Denial

Subject: Mine Ventilation Plan, Section 75.370, 30 CFR 75, Upper
Big Branch Mine-South, I.D. No. 46-08436, Performance
Coal Company, Montcoal, Raleigh County, West Virginia

PLAN TYPE: REVISION-REROUTE THE RETURN OFF OF THE MMU 029-0 SECTION AND MAKE THE RETURN ENTRIES INBY THE LW COMMON

Re: Performance Coal Company
Upper Big Branch Mine
MSHA ID : 46-08436
State ID: U-3042-92
Ventilation Revision

PERFORMANCE COAL COMPANY, INC. P.O. BOX 68, NAOMA, WV 25140		
	UPPER BIG BRANCH MINE		
M.S.H.A. ID No. 46-08438	WV ID No. U-3042-92		
Date: 11/20/09	SCALE: NA	DWG No. 1 of 1	
DRAWN BY: RL 3 Staff	CHECKED BY:		
Face Ventilation Typical Gateroad Development			
VENTILATION PLAN

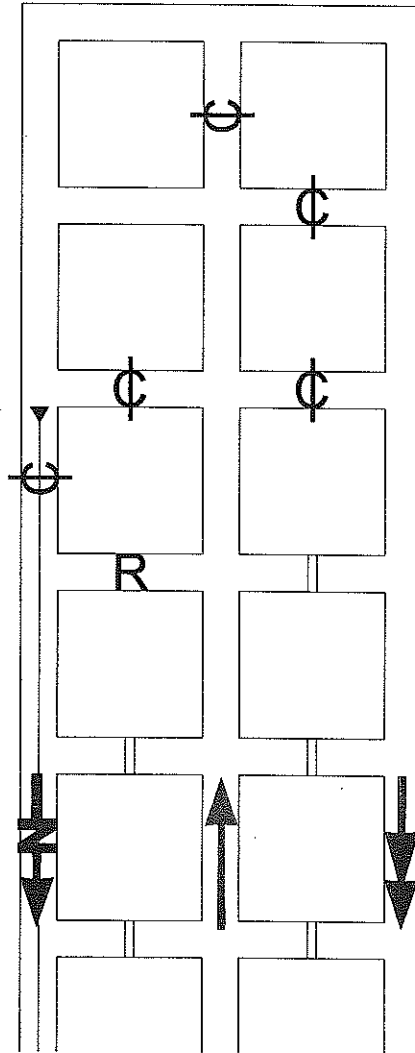
Attached for your review and approval is a ventilation revision for Performance Coal Company's Upper Big Branch Mine (46-08436). This revision is to reroute the return off of the MMU 029-0 section and make the return entries inby the longwall common. — *this is not shown on the accompanying map.*

A drawing is attached showing the controls to be removed and installed for this revision. The return off of MMU 029-0 will be routed down the left side North Glory Mains where it will cross overcasts on Headgate 1 North and be sent up Tailgate 1 North to the return shaft. The previous return entry will be made common with the belt along the #2 Crossover and with the longwall intake along Headgate 1 North. EP-LW1 will now include the #3 entry. A point feed regulator will be added at the #1 Crossover on Headgate 1 North. A face sketch is also included showing mining with the #1 entry containing the belt. This scheme will be used to mine Headgate 2 North. This revision is limited to the changes shown. All previously approved plan contents will be adhered to. — *this plan conflicts with previous approvals granted September, October 29, 2009 and November 13, 2009.*

*not acceptable
statement for a
longwall plan.*

PERFORMANCE COAL COMPANY		UPPER BIG BRANCH MINE	
MSHA ID No. 4049438	WV ID No. L13042-82	SAFETY PRECAUTIONS FOR WATER	
DATE 12-03-2009	DWG No. 1 of 1		
DRAWN BY: R. J. SMITH	SCALE: 1"=400'		
		CHECKED BY: AW

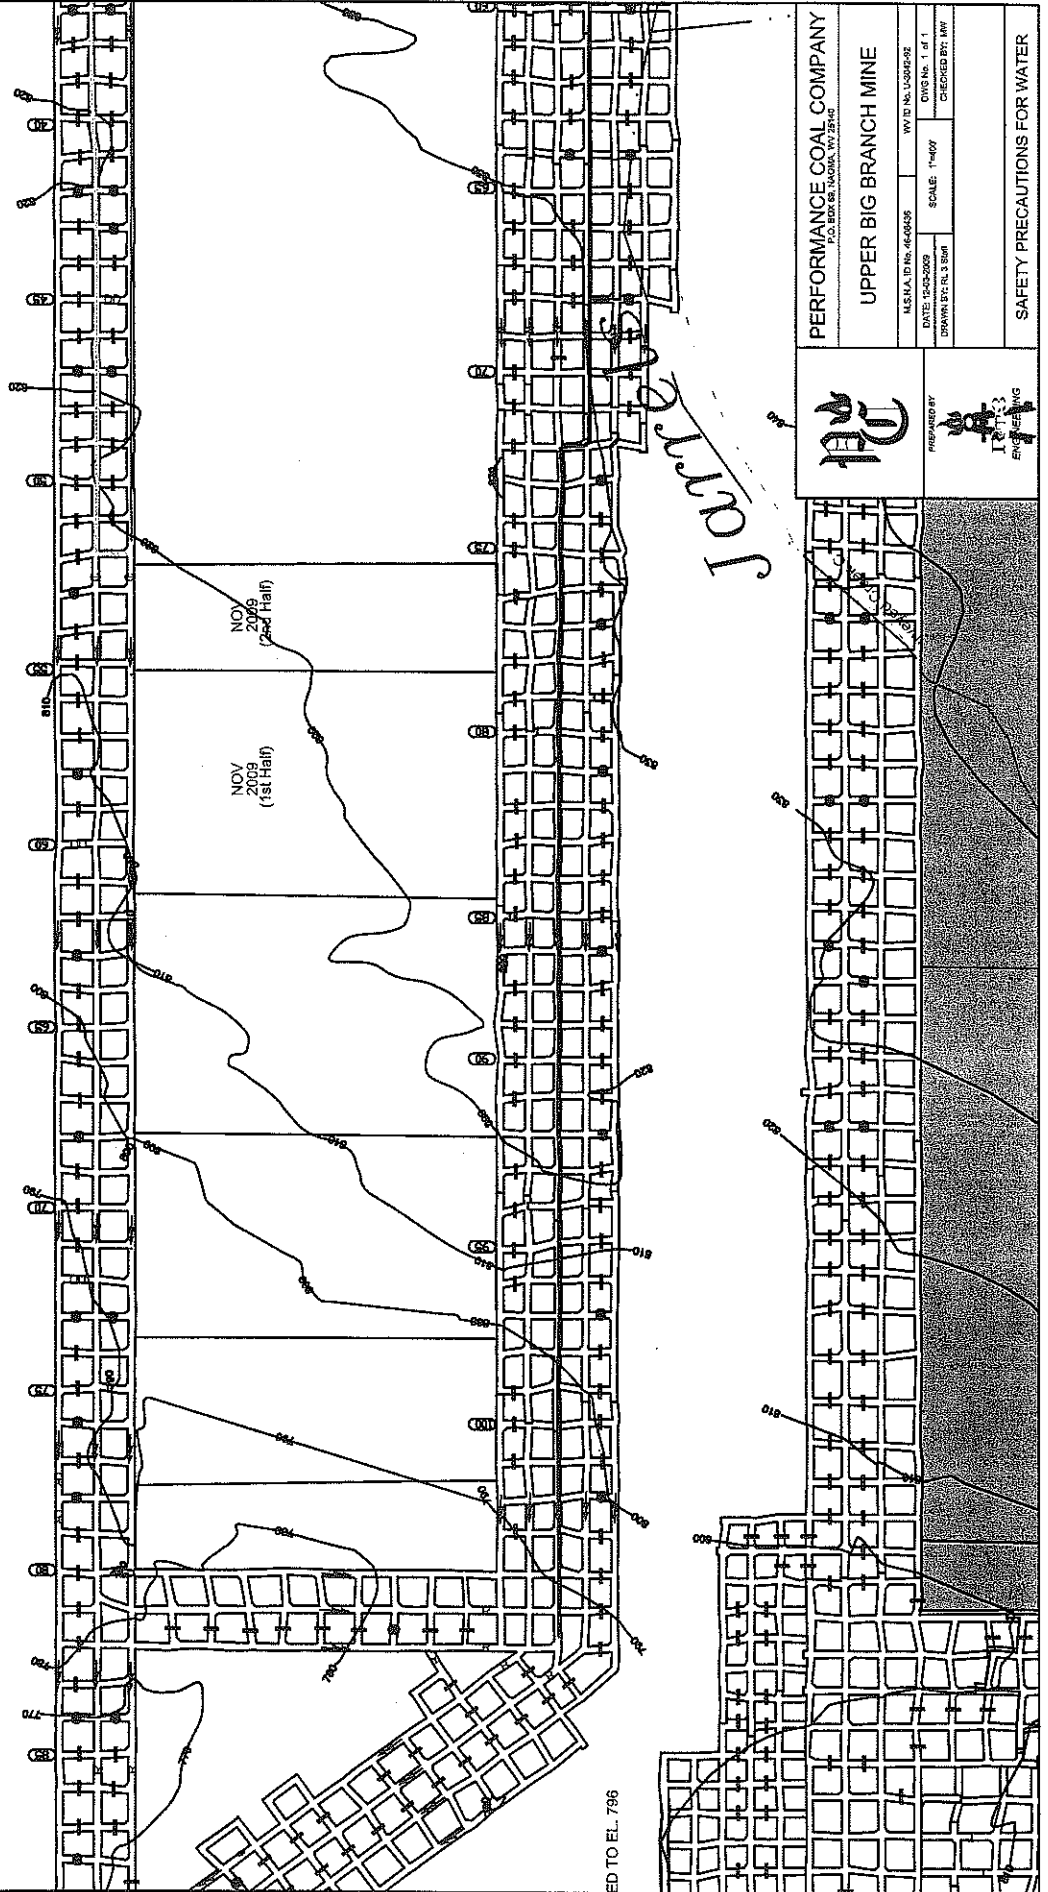
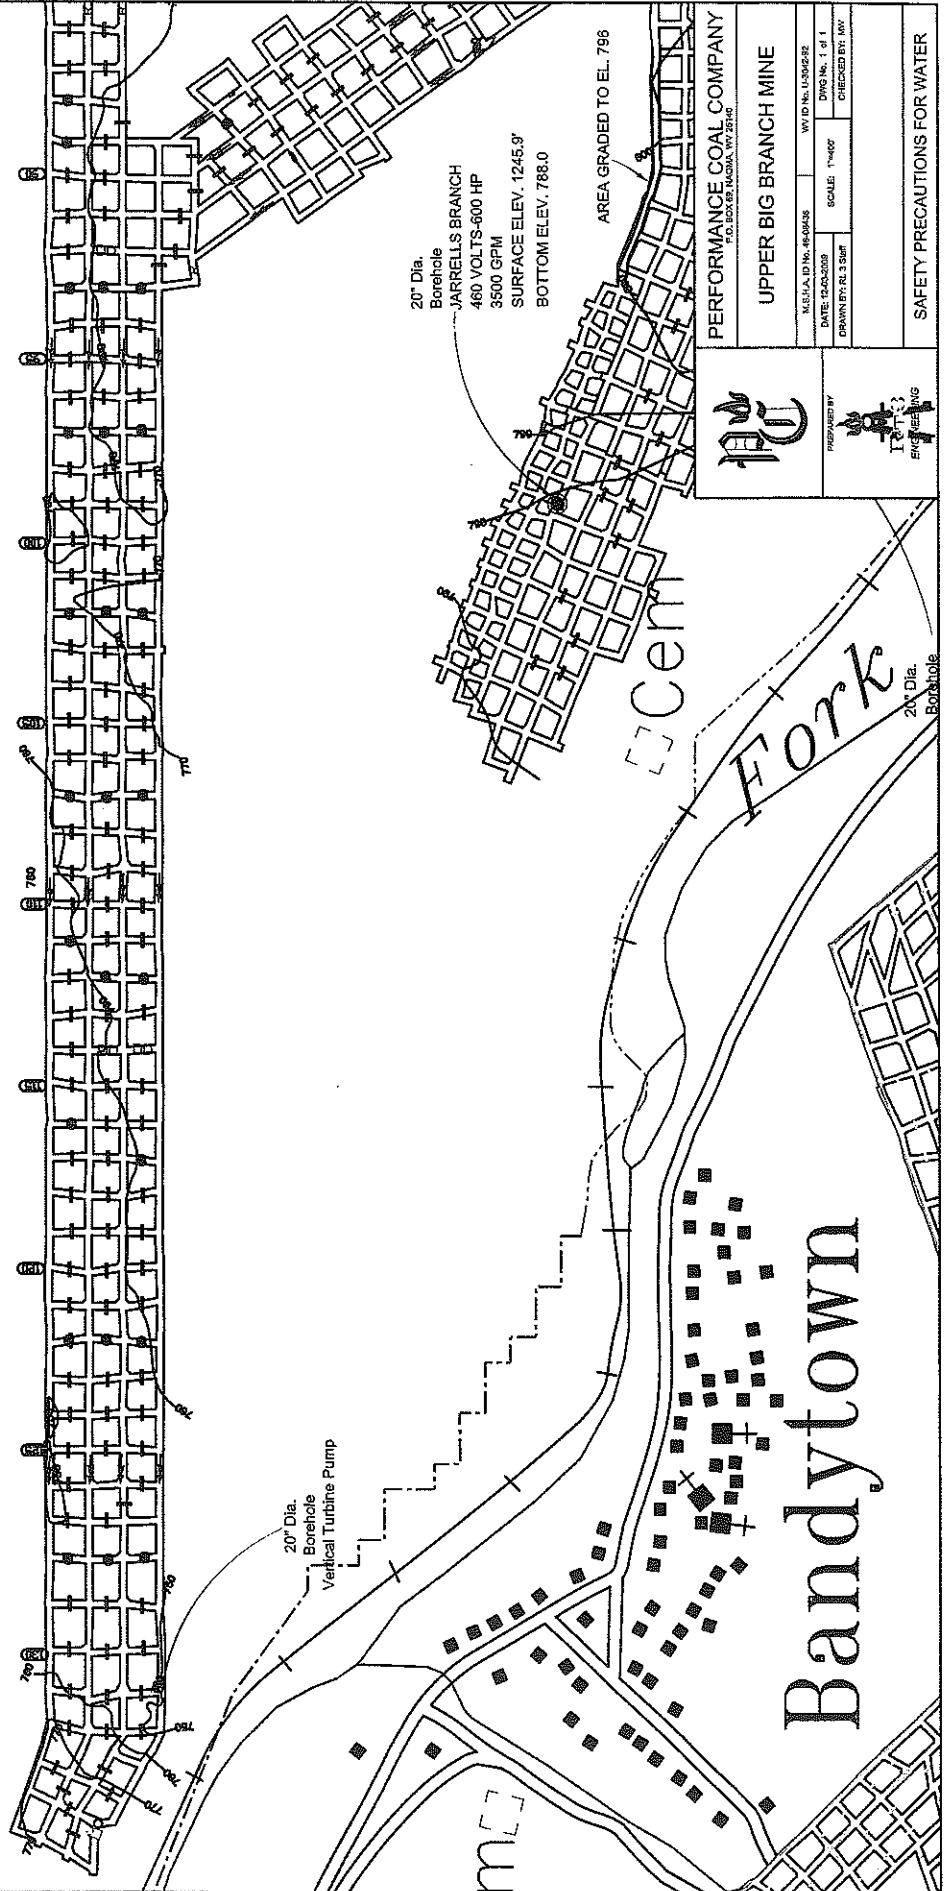
In addition, the submittal does not clarify how the return stopping line shown on the longwall face sketch is to be traveled or maintained, adequate details if the air courses are to become common or if the return stopping line is to be reconstructed. Measuring Points (MP) shown on the face sketch must also be checked for proper air direction. Furthermore, the gate road development face sketch (3-entry) contains a statement, "Number of entries may vary provided the ventilation scheme does not change." which is inappropriate for the projections and system shown on the attached maps.

TYPICAL LONGWALL FACE VENTILATION

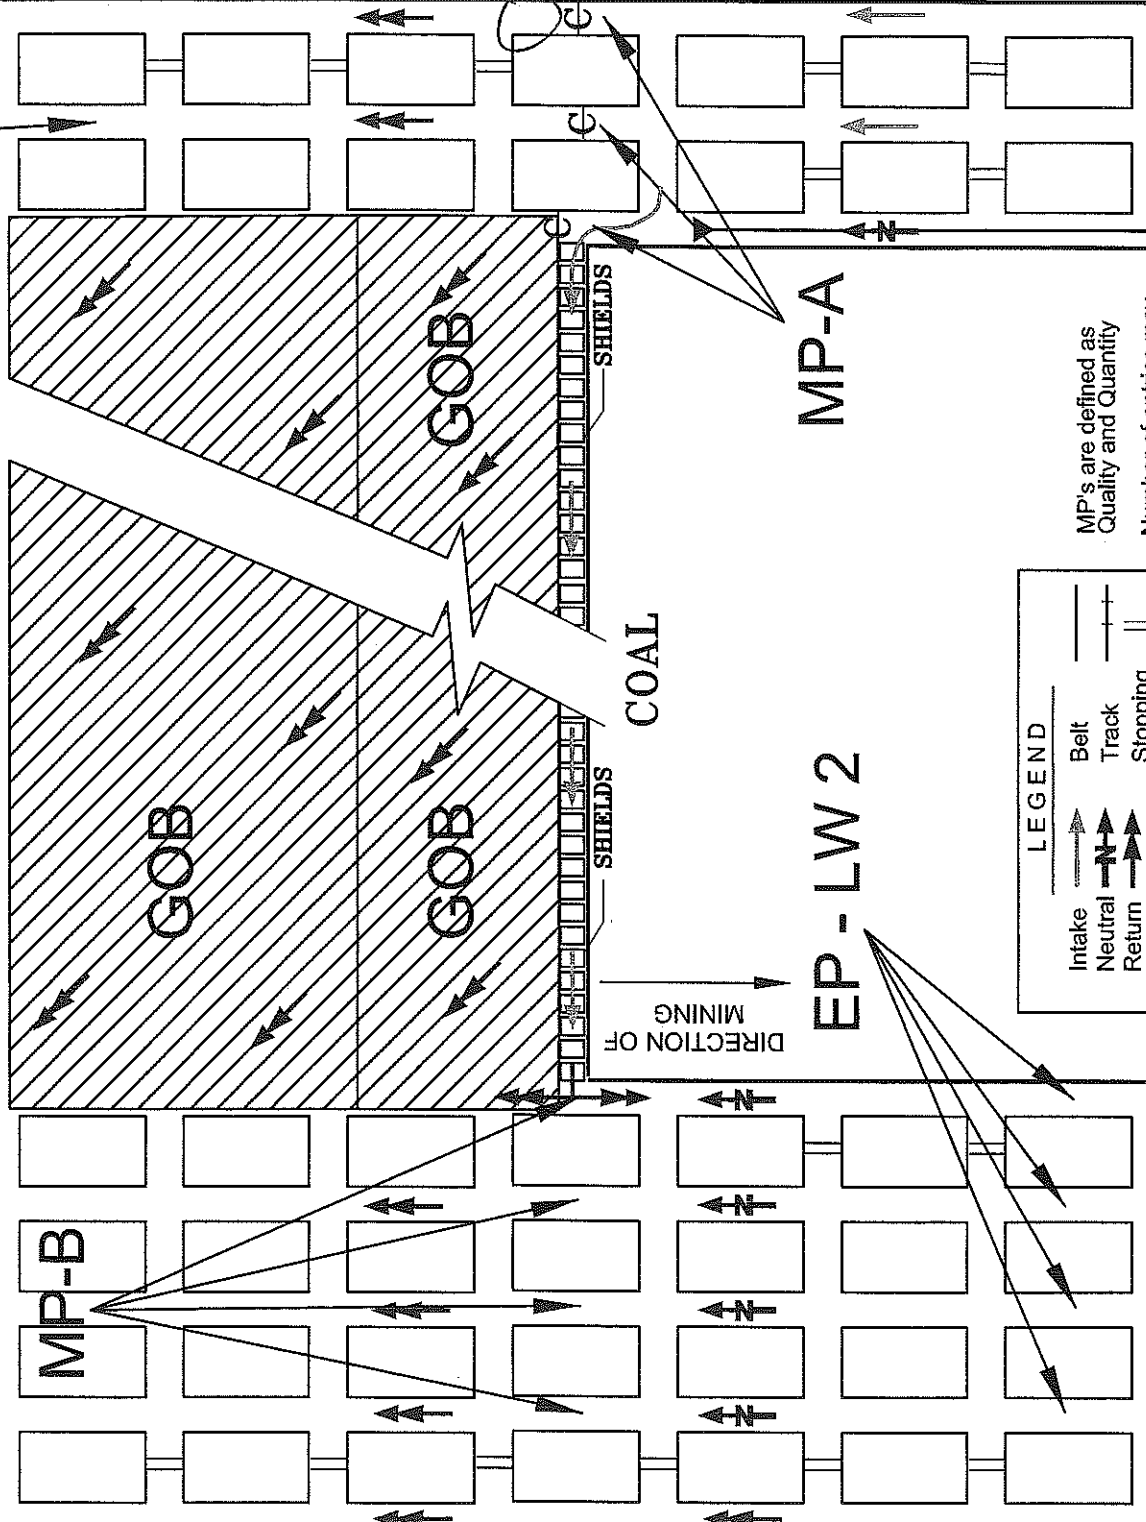
*Hand are to be reconstructed
 Can this return split be traveled into the long wall face?
 MP will be required*

- 1) Face sketch
 - 2) Mine controls match 10/29 & previous revisions
 - 3) Volumes @ each split/regulator
 - 4) Bottom Contours - ~~foot~~
 - 5) location of roof falls
 - 6) location of water accumulations.
 - 7) Commitment on ~~o~~ No 2nd panel.
 - 8) Reason(s) why common air is necessary.
 - 9) location of 2 ways into bleeder system
(how will this be done?)
- 10) Pump locations + size - minimum pump size
+ locations. → 75.334(L)
